## Observation Report

Re: Meadow Creek Condominiums, Vail, CO  
(Building E)  
Project No. 0307-19 E

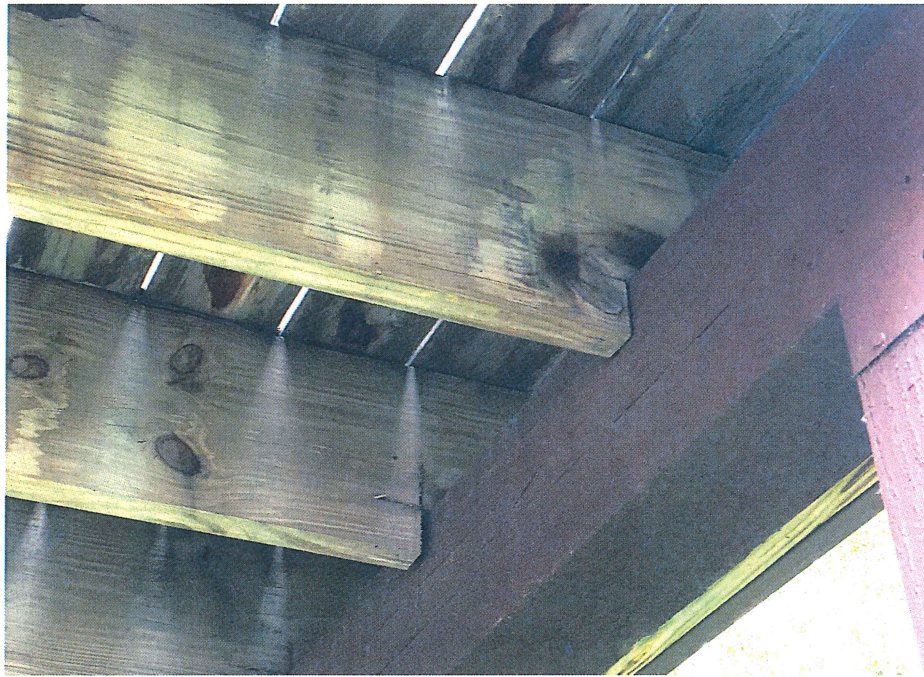
Unit E6: This deck appears to have been remodeled at some point in time. The deck is connected to unit E5 and is separated in the middle by a framed partition wall. The deck to the south of the cantilevered floor from above appears to be framed with 2x8 deck joists spaced at 20" on center with older 2x6 decking. The deck to the north of the cantilevered floor from above appears to be framed with 2x10 deck joists spaced at 16" on center with newer 2x6 decking. The paint that was applied to the underside of this decking and joists has mostly peeled away. Some nails appear to be weathered and show signs of rust. Some of the deck joists are cracking in areas and they appear to be taking on a blackish/gray weathered look. Most of the joists bear on mechanical steel hangers or are toe-nailed on the east end and cantilever approximately 10" on the west. The east end hangers are nailed to either a 2x8 or a 2x10 ledger that is perpendicular with the deck joists or toe-nailed to a 4x10 ledger that is on an approximate 45 degree angle to the deck joists. The 4x10 ledger to the north side of the cantilevered

floor from above appear to be lagged into the cantilevered floor from above at the top. The cantilevered ends of the deck joists bear on dropped 6x8 beams. It appears as though the 2x10 deck joists to the north of the cantilevered floor from above have been notched over the 6x8 dropped beam and some have been over cut in areas. (See Image J) The 6x8 beam to the south spans continuously over three separate 6x6 posts that also supports some of the E5 unit deck. Where the 6x8 beam bears on the 6x6 post there is a large diagonal crack. (See Image K) The 6x8 beam to the north spans continuously over two separate 6x6 posts and cantilevers over the post to the north approximately 8". The posts are spaced out randomly with the largest spacing being approximately 8'-2" and smallest spacing being approximately 3'-6". It appears that where the 6x8 beams bear on a 6x6 post there are some mechanical steel caps. The 6x6 posts bear on concrete circular piers and do not appear to have a mechanical steel base plate. The piers are about 3 to 8 inches above the grade.

6. For unit E6, sister a 2x8 to the existing 2x10 deck joists with three rows of 8d nails at 16" where they have been over cut.
